CALL NO. 102
CONTRACT ID NO. 141041
ADDENDUM # 1

Subject: Pulaski County, HSIP 5105 (035)
Letting August 22, 2014

- (1) Revised - Plans - R1, R2, R2A, R2B, R3, R5, R11, & X14
- (2) Added - Special Notes - Pages 17(a)-17(c) of 105
- (3) Revised - Bid Items - Pages 104-105 of 105

PULASKI COUNTY
KY 70 IMPROVEMENTS AT BUCK CREEK
HSIP 5105 (035)
FD52 100 0070 009-010

COUNTY OF	ITEM NO.	SHEET NO.
PULASKI	8-926.00	R2

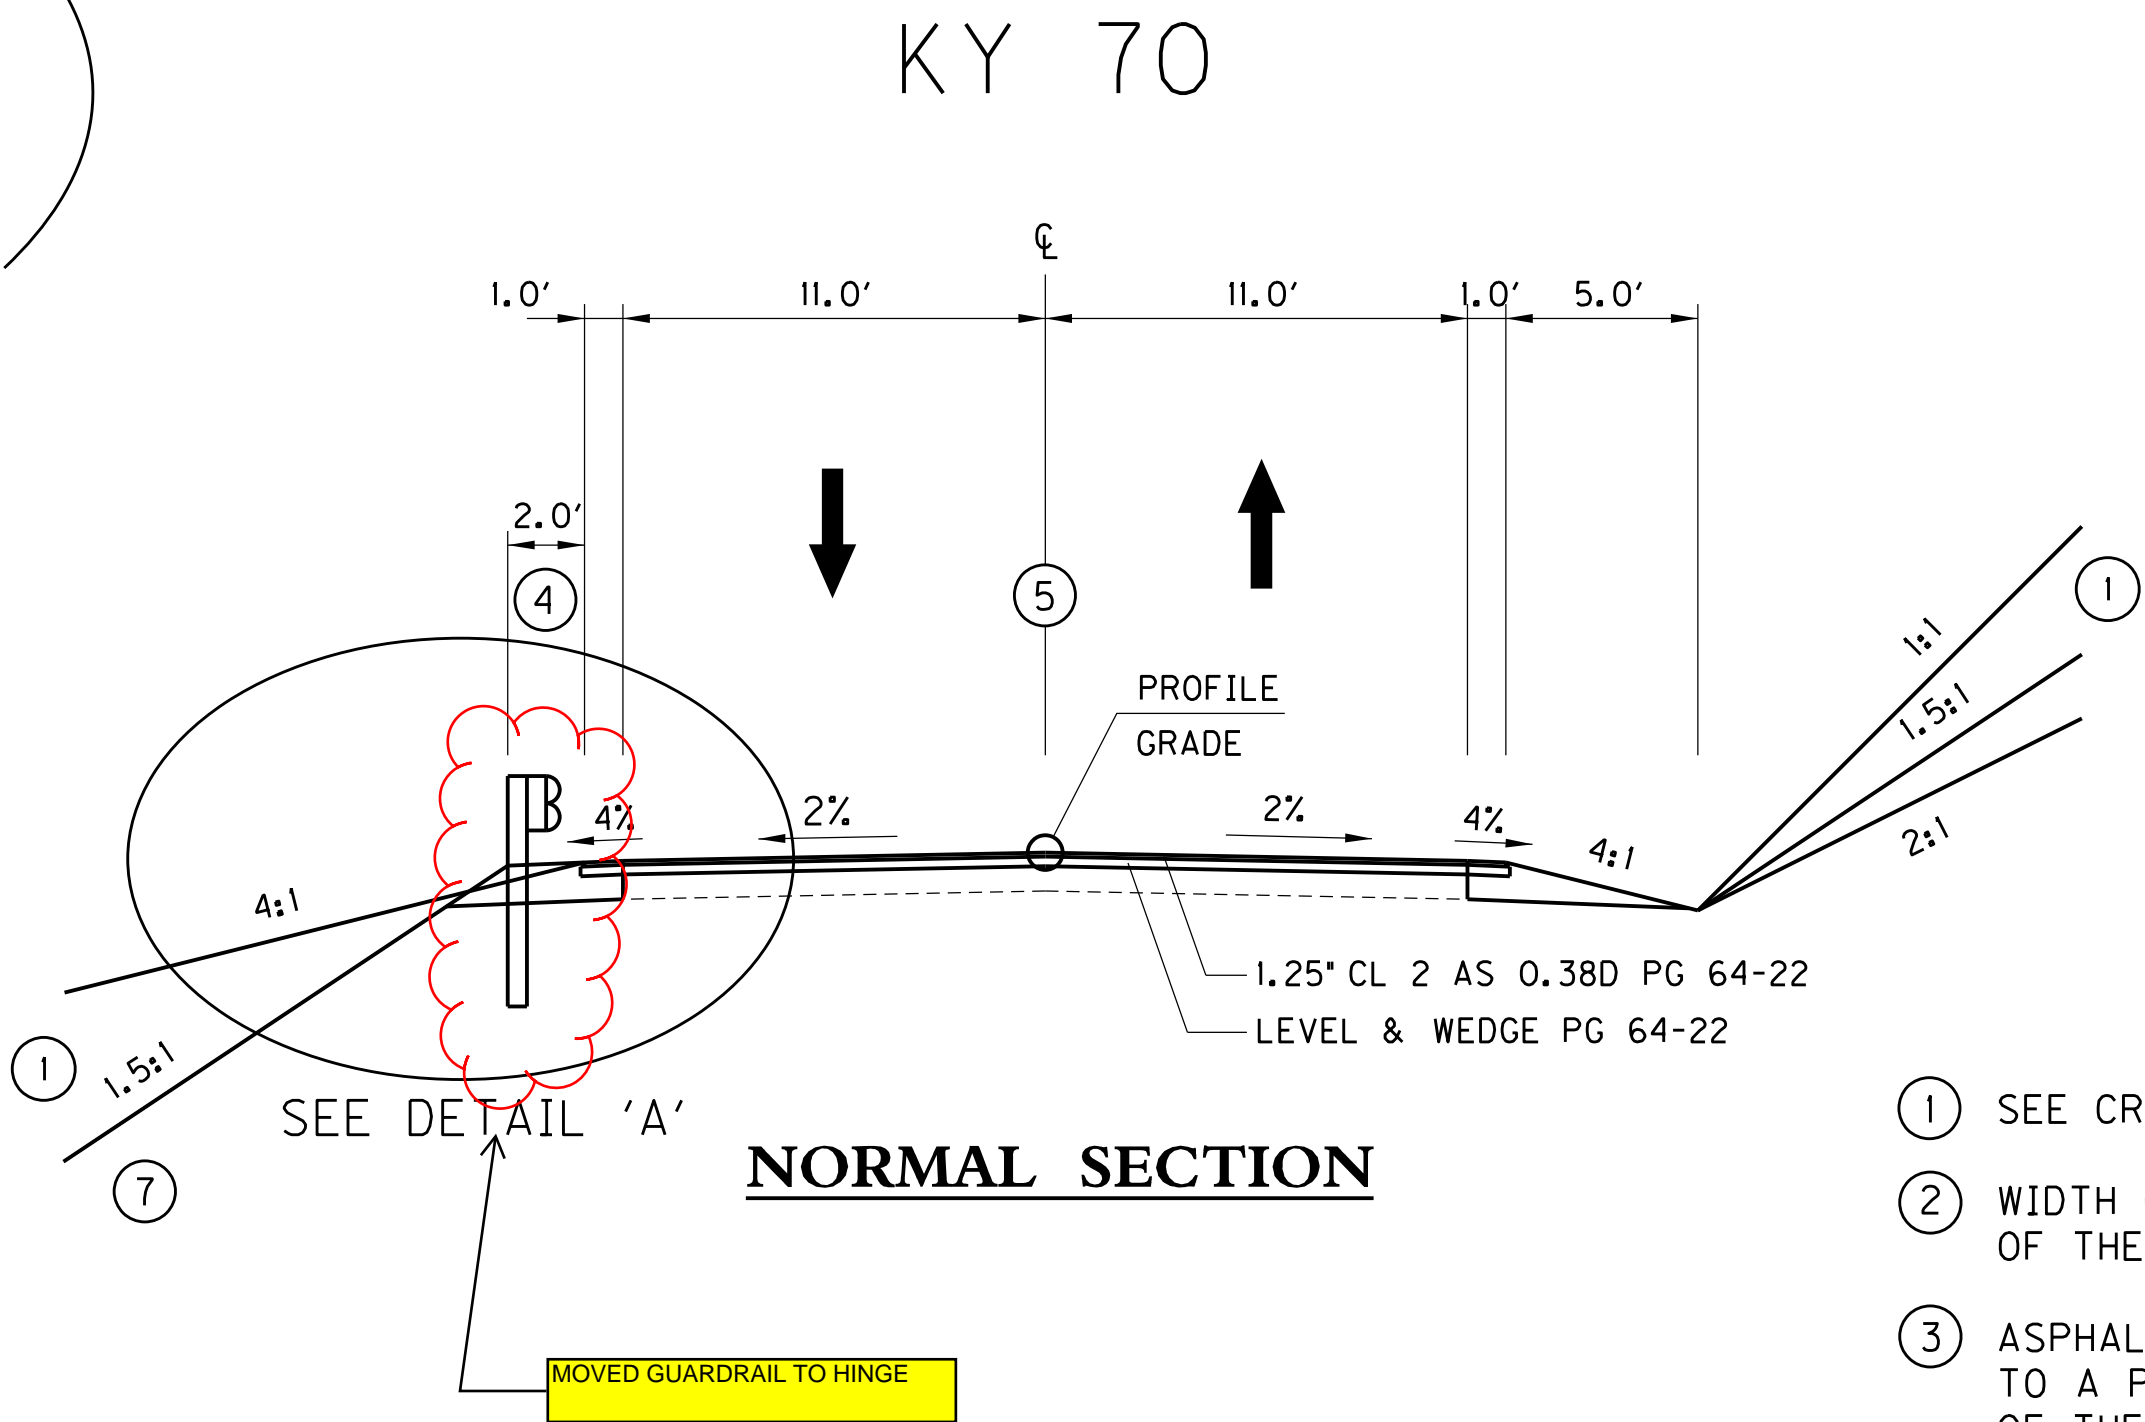
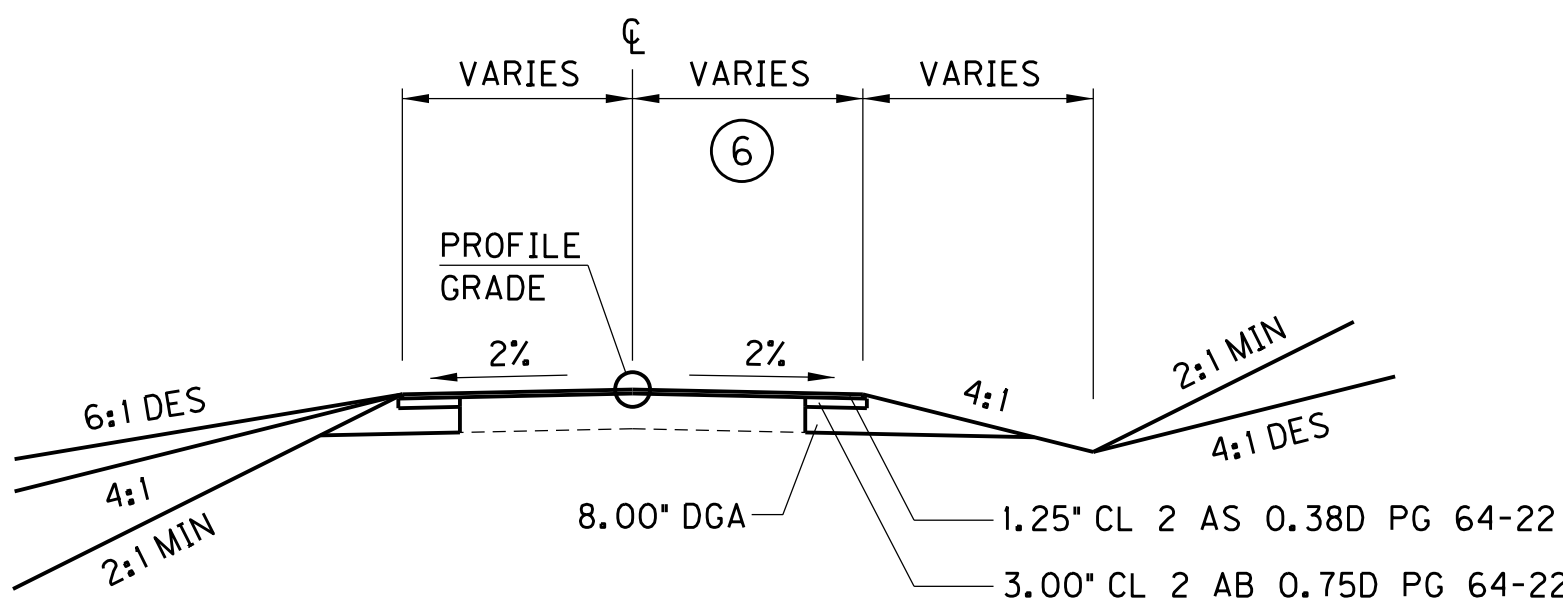
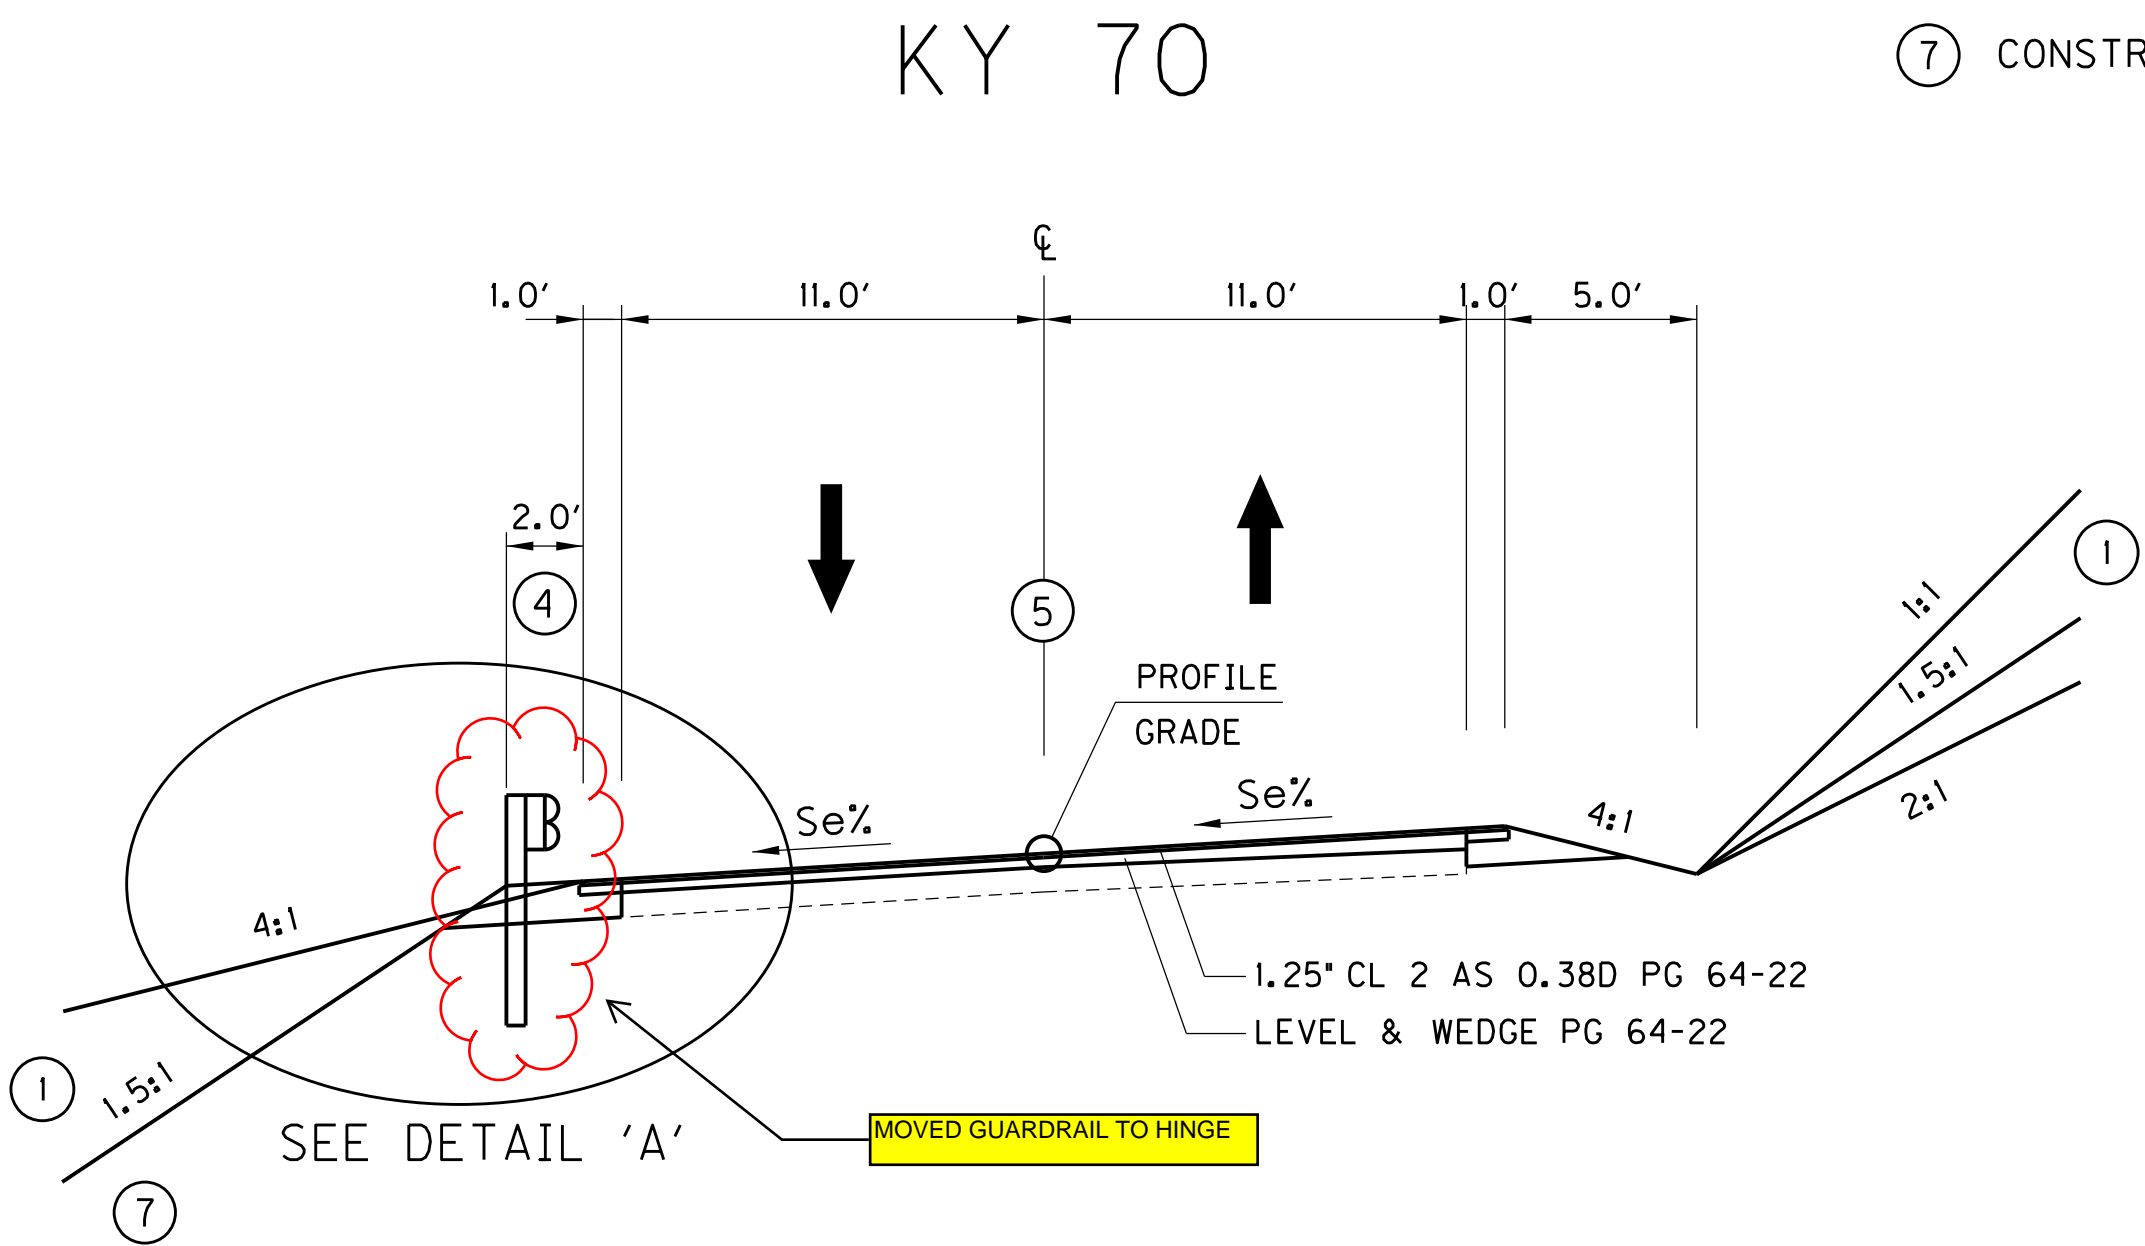
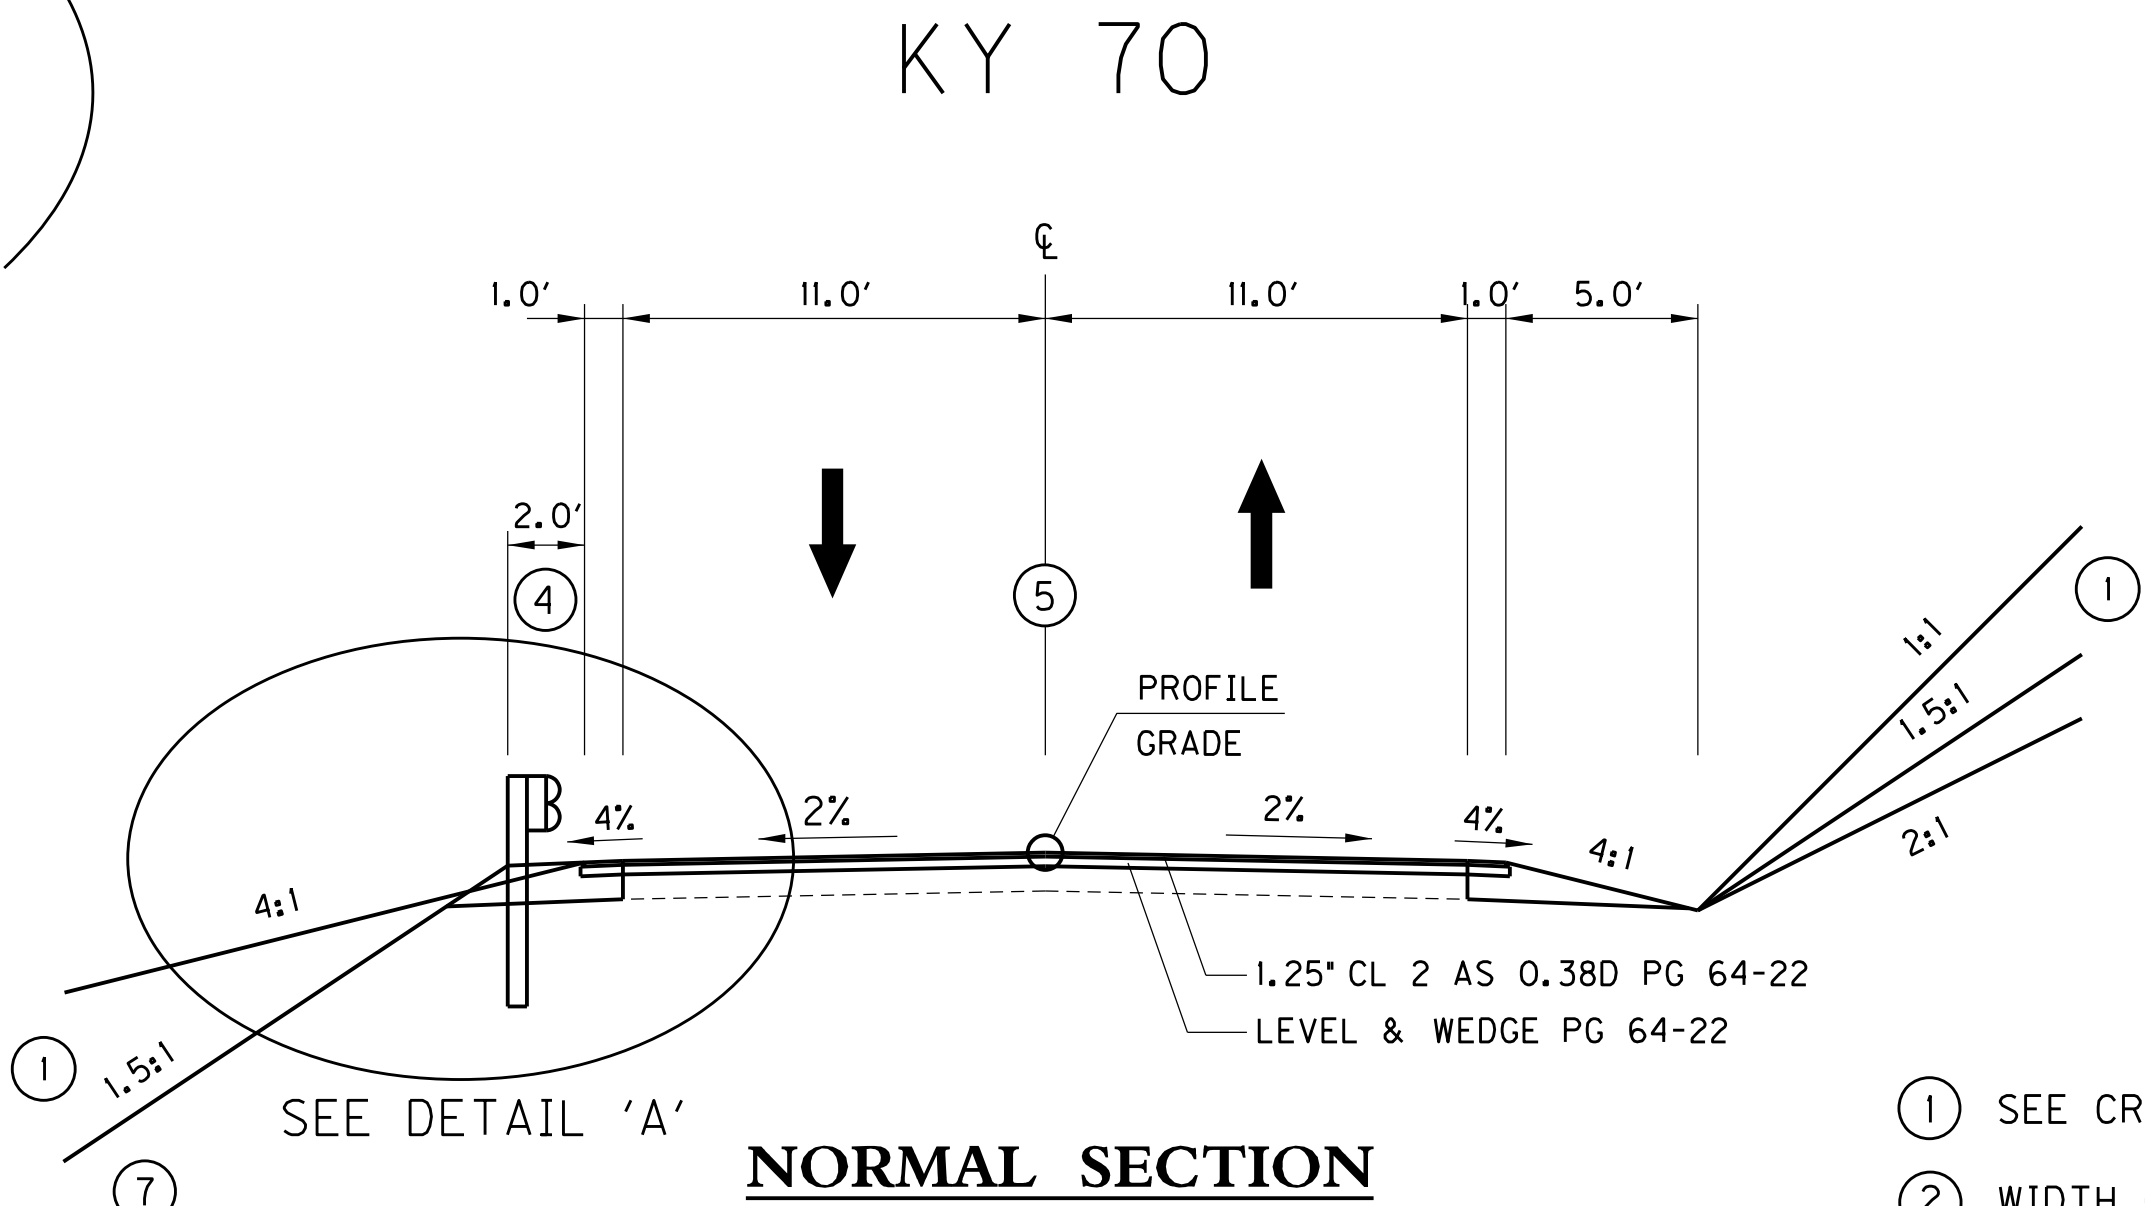
CHANGED NOTE TO INDICATE 9 FT POSTS
